STAFF RECOMMENDATION
2416 West Linden Avenue
December 16, 2020

Application: New Construction—Addition and Outbuilding
District: Hillsboro-West End Neighborhood Conservation Zoning Overlay
Council District: 18
Base Zoning: RS7.5
Map and Parcel Number: 10415025800
Applicant: Phil Hyde
Project Lead: Melissa Baldock, melissa.baldock@nashville.gov

<p>Description of Project: Application is to construct a rear addition that extends wider than the historic house, enclose a side porch, and construct an outbuilding.</p> <p>Recommendation Summary: Staff recommends approval with the following conditions:</p> <ol style="list-style-type: none">1. The concrete block be split face and that staff approve the windows, doors, roof shingle color, and driveway material prior to purchase and installation; and2. The HVAC shall be located behind the house or on either side, beyond the mid-point of the house. <p>With these conditions, staff finds that the proposed addition and outbuilding to meet Sections II.B.1., II.B.2., and III.B.2. of the design guidelines.</p>	<p>Attachments A: Site Plan B: Elevations</p>
--	--

Figure 1. 2416 West Linden Avenue

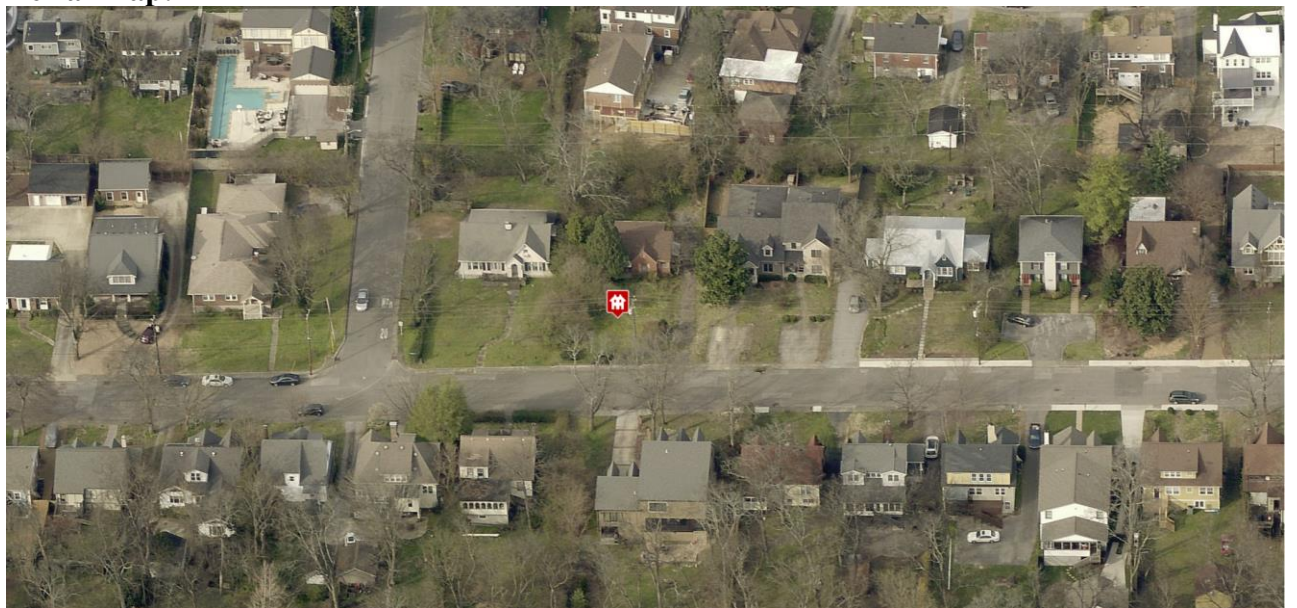
Background: 2416 West Linden is a c. 1940 Minimal Traditional brick house that contributes to the historic character of the Hillsboro-West End Neighborhood Conservation Zoning Overlay (Figure 1).

Figures 2 & 3 are the existing and proposed right facades.

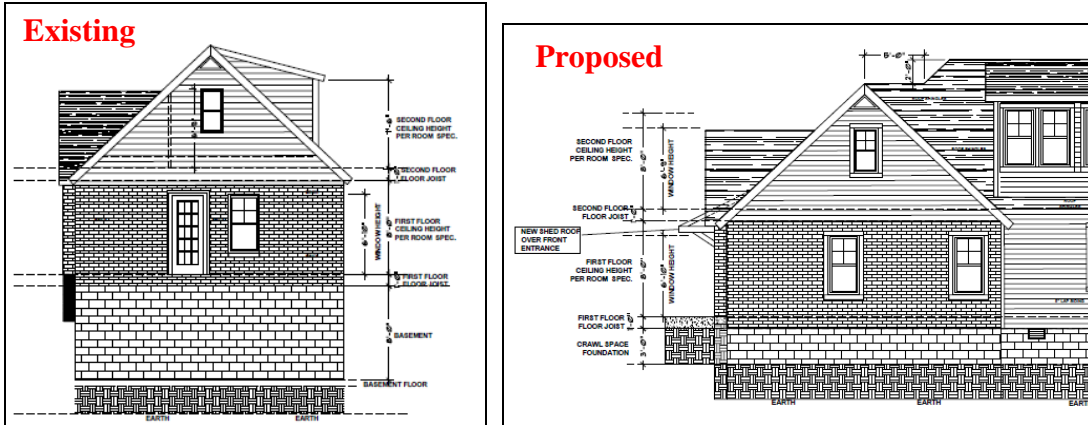
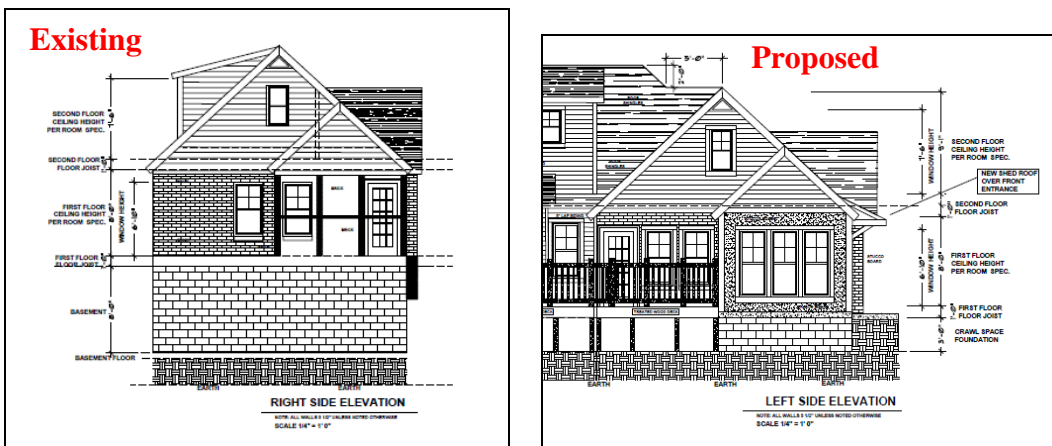
Demolition: The applicant intends to alter window and door openings, which is considered partial demolition. No changes to the window and door openings on the front façade are proposed. On the right-side façade, an existing door will be altered into a window opening, and the window openings on the back half of the house will be shifted (Figures 2 & 3). Staff finds that because the door-to-window opening is minor and the other changes happen in the back half of the house, the partial demolition meets the design guidelines.

On the left façade, the existing side porch will be enclosed so the window changes behind it will no longer be visible. One window and a door opening will be added behind the enclosed side porch (Figures 4 & 5). Staff finds that the changes to the window openings on this façade to meet the design guidelines because they occur in the back half of the house and will be obscured by the side porch.

Staff finds the alteration of the window and door openings to meet Section III.B.2. of the design guidelines.
